Meeting Date:
July 8, 2024

Request: Preliminary
Subdivision review of
Canterbury Crossing

Hudson Planning Commission	PRELIMINARY SUBDIVISION REVIEW
Case No. 2023-676	CANTERBURY CROSSING

Figure 3

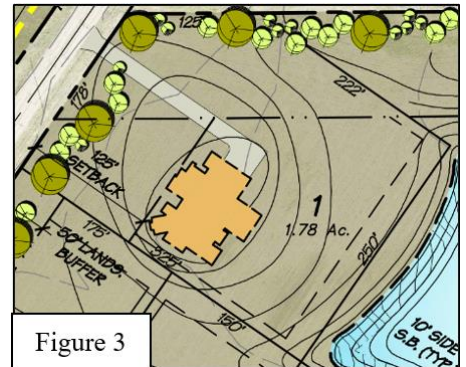
Staff Comment: All buildings are depicted with a minimum setback of 100 ft from the perimeter property line; however, staff notes sublots #1 and subplot #13 would have significant portions of the lots with the minimum 100 ft structure setback. In conflict with the conditional use standards referenced under section 1206.

Figure 4

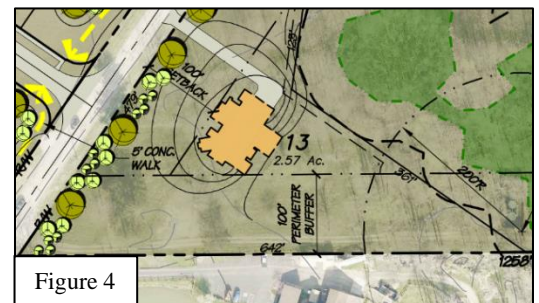
Staff Comment: A substantial bufferyard is depicted within the 100 ft perimeter setback; however, landscaping would need to be verified for subplot #13 (See Figure #4). Staff notes the proposed limits of disturbance indicate existing vegetation would be preserved along the southern property line; however, the extent is not captured on the landscaping plans. Removing this subplot out of the 100-foot perimeter will allow the protection of existing vegetation to count towards the required bufferyard.

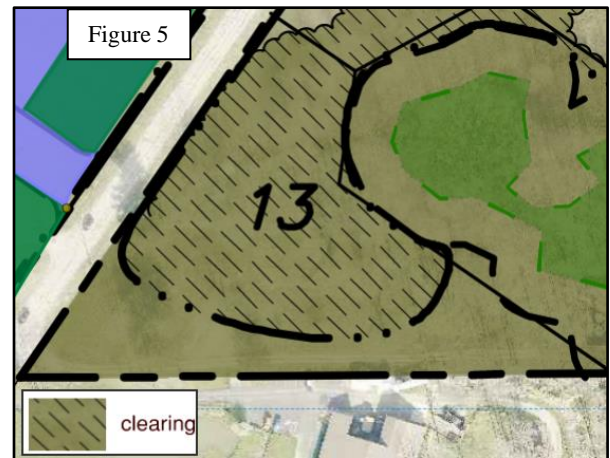
Staff suggests the removal of subplot #13 per the following findings:

1. The proposed lot shape does not fit with the proposed development or surrounding existing lots. Section 1208.05 states *the lot size, width, depth, shape, and orientation shall be appropriate for the location of the subdivision and type of development and use contemplated.*
2. In order to accommodate a new house on this lot substantial clearing would be required (see Figure 5). Staff notes the proposed lot is located adjacent to an existing single family house lot.
3. As previously mentioned, this is one of the few locations where the required perimeter property setback would not incorporate dedicated open space as discussed to comply with applicable conditional use standards.

1. Remove subplot #13 to comply with the lot design standards, tree clearing standards, and minimum density standards and to establish a 100 foot depth open space acreage at the subdivision boundary.

Figure 6

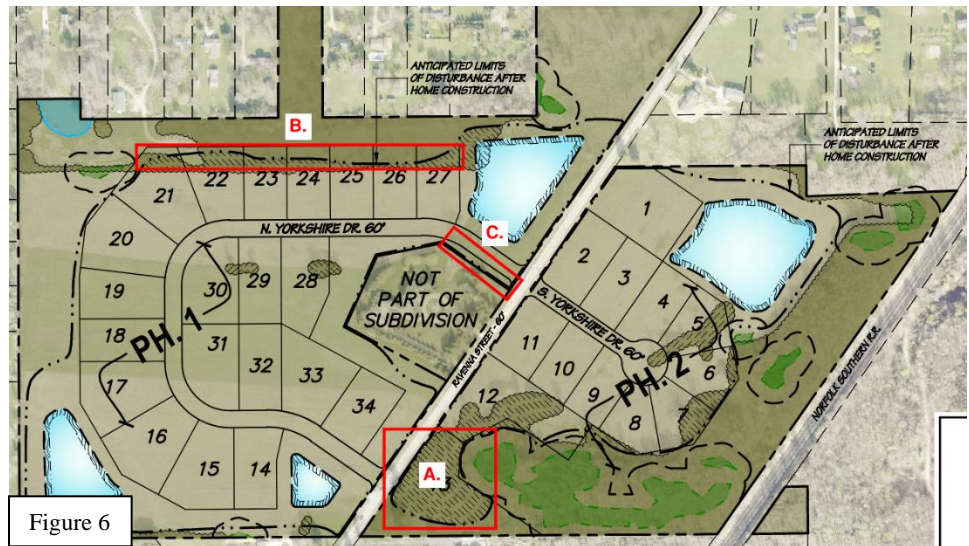
- **Area A:** As previously stated, development of subplot #13 would require significant clearing of mature trees. These trees are generally healthy as observed by the City Arborist.
- **Area B:** The site plan indicated clearing a portion of the rear yards along sublots #21-#27. The City Arborist noted an invasive form of pear trees along this tree line. Staff also notes the landscaping plan states additional plantings would be installed to establish the required Bufferyard C in this area.
- **Area C:** Staff notes mature pine trees along the proposed drive entrance. Question if these trees would be impacted by the drive and necessary grading work.

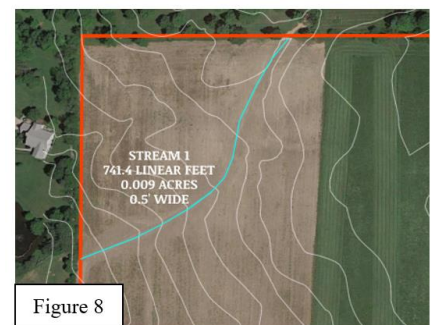
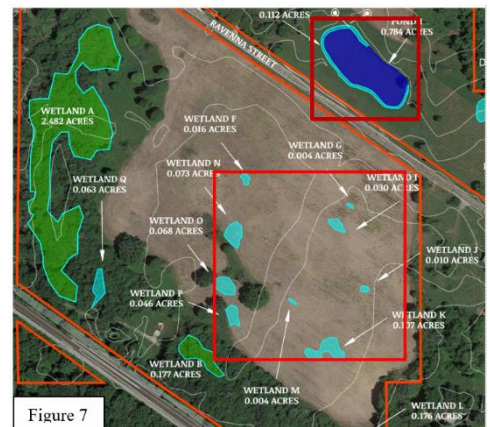
Since the Compatibility Reivew, the developer has been able to communicate further with the ACOE; however, a final Jurisdictional Letter has not been issued. Staff understands the ACOE visited the site and noted several additional wetland pockets (Figure 7) and that the drainage way referenced above is a stream (Figure 8). Staff notes that to be able to fully review the proposed subdivision layout, the requested consultant letter should be submitted along with full wetland delineation and ACOE jurisdictional letter.

The applicant states the 0.496 acres of wetland highlighted would be proposed to be filled to accommodate the new home construction on the south side of Ravenna Street and at the proposed street right of way. The applicant states these wetlands are expected to be classified as isolated and only under the direct jurisdiction of the Ohio EPA. Disturbance of these wetlands would additionally require a variance request to the BZBA.

The applicant is proposing the identified stream to be re-routed and integrated into a stormwater basin. Staff notes remnants of clay tile piping has been observed within the stream bed, suggesting the stream was once a controlled drainageway. This area, if regulated as a stream, requires riparian setback protection which must be depicted on the plan. Any modification to the applicable standards would require a variance request to the BZBA.

An existing pond along Ravenna Street would also be re-established as a stormwater pond. Staff anticipates this pond will also need to be redesigned or a variance request would be needed for the wetlands depicted along the pond edge.

Both the fill of the wetlands and the rerouting of the stream would be in conflict with Section 1207.03, which states “No person shall engage in any activity that will disturb, remove, fill, drain, dredge, clear, destroy, or alter any area, including vegetation, within stream corridors, wetlands, and their setbacks, except as may be expressly allowed in this Code.”

The wetland and stream corridors, with applicable setbacks, need to be accurately depicted on the plan submittal. Formal review of these standards can not be completed until such is accurately depicted and the jurisdictional letter issued by the ACOE. Of note, it appears the stream corridor could be preserved or its alteration significantly reduced and the proposed wetland impacts may not be necessary is the street and/or sublots could be adjusted.

5. Revise the landscaping plan shall be revised per the following City Arborist and Community Development staff comments
6. Submit the previously requested documentation from the wetland consultant included the full, updated wetland and stream delineation along with the Jurisdictional letter from the Army Corp of Engineers. The documentation is critical to be able to proceed with full review of the appropriate subplot layout, positioning of open spaces, and the grading/stormwater design.
